**Prosecution Team Case-in-Chief  
Confusion Hill Bypass Project**

### Notice of Discharge, Written Notice, or Order

Subject: Notice of Discharge

Project Name: Realign Highway 101 and construct two bridges at Confusion Hill

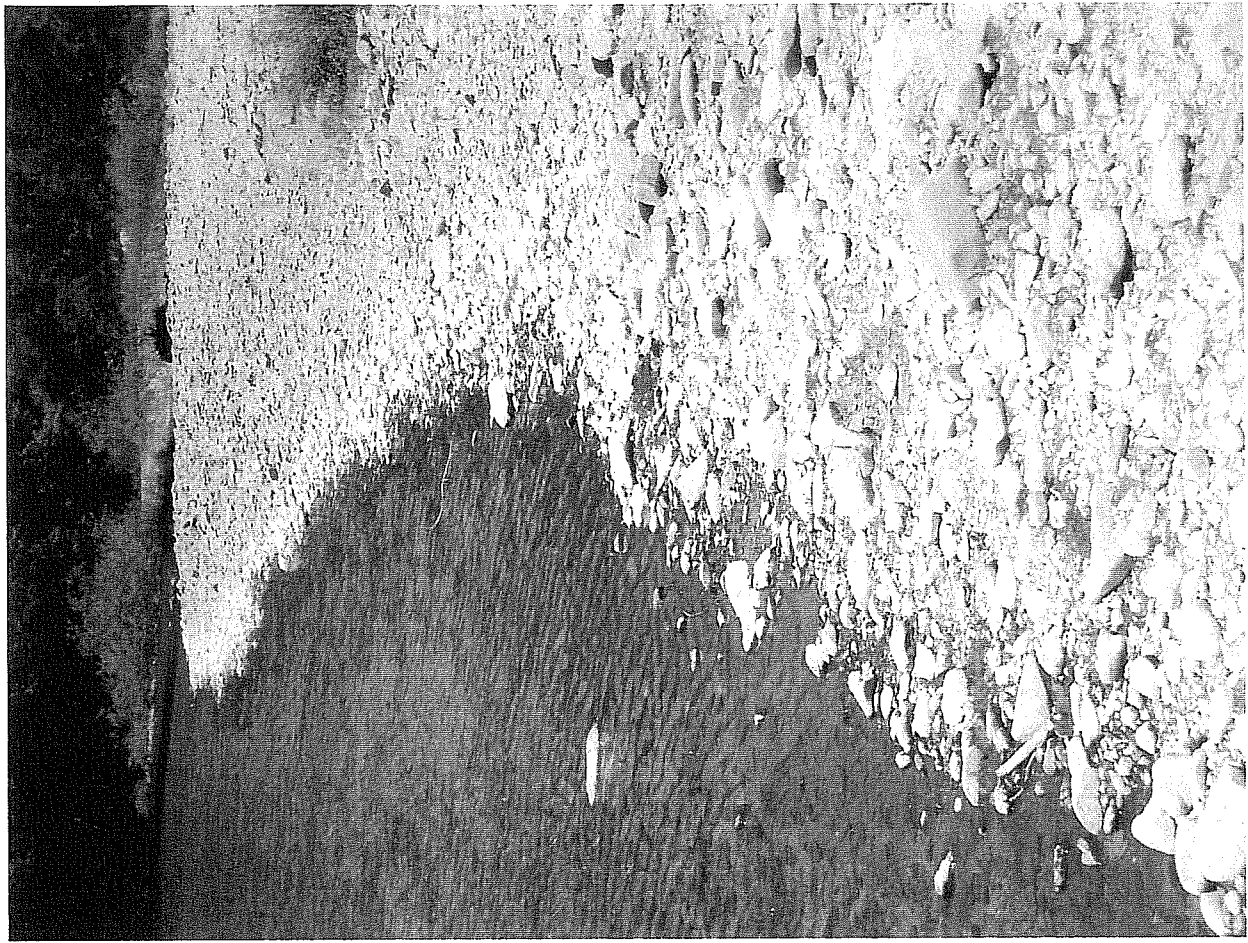
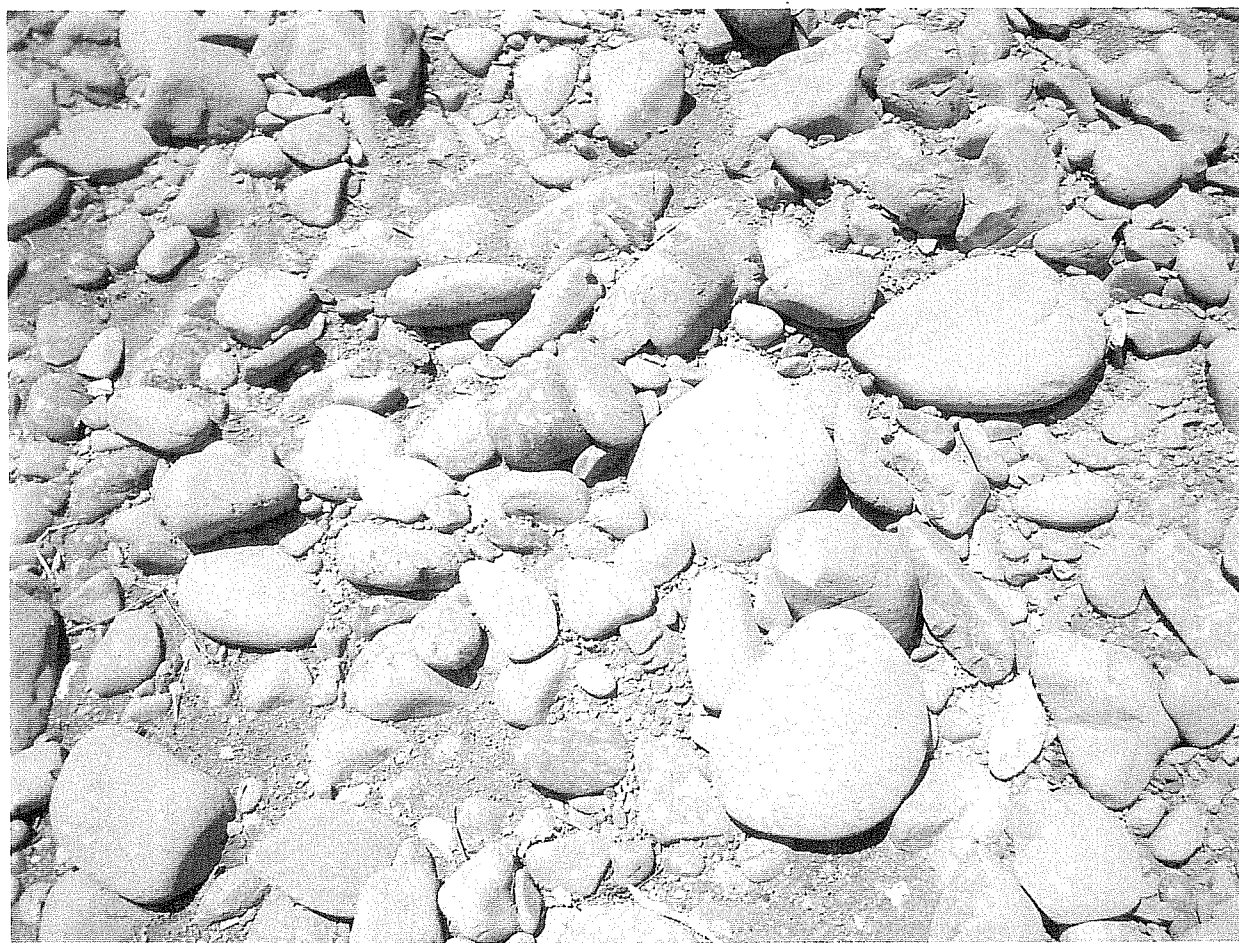
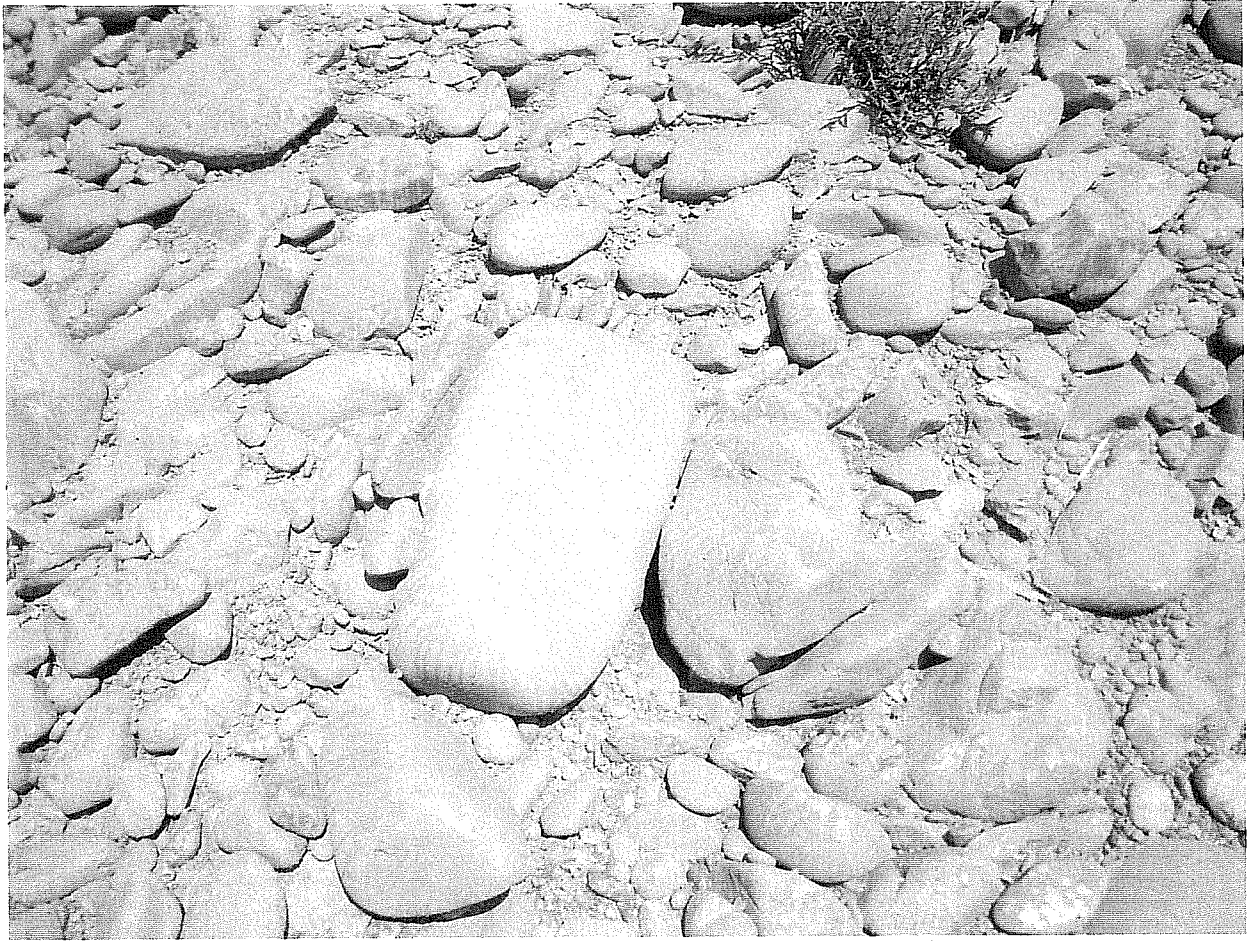
What are the revised BMP measures that the sub-contractor submitted? You should have secondary containment around all pressurized lines above the river before the contractor gets back to work. Is that what you mean by the BMPs installed for "a hole in the pressure line type leak?" Did the spill get cleaned up off of the gravel bar and river? How? The Attachment K that you sent us only contained the first page, can you send the second page too? Did you send in a hard copy?

I will provide picture of the grout equipment and all apparatus in action, with BMPs installed (both for a gravity leak and a hole in the pressure

The BMP measures were / are simply more of the same except for implementation of a lower grouting pressure; implementation of a stronger grout delivery line; placement of a horizontal barrier that would encase any high pressure grout leaks. Better and more significant containment for any sudden grout leaks is what is being implemented, whether the leaks be from a break in a line under pressure, or from a spill on deck. I had a mtg specifically with this sub and the prime prior to any grouting about the importance of grout control BMPs; the importance of proper maintenance and implementation; and my staff has been on them fairly significantly. All was going well, but the freak leak is just that.

The grout that hit the rocks that can be seen in the photos is hard as a rock. Absolutely no cleanup was done. The prime wanted to go and clean-up all of the rocks that have grout on them, but we did not allow this as it was sure to cause more impact by going on the river bar and trying to clean dry, hard, inert grout. I told them that any clean-up orders would occur after agency consultation. My staff says that the grout dried within several minutes, as the small drips on the rocks was thin. The grout is essentially concrete waster with no aggregate, so once it is dried, it should be inert.
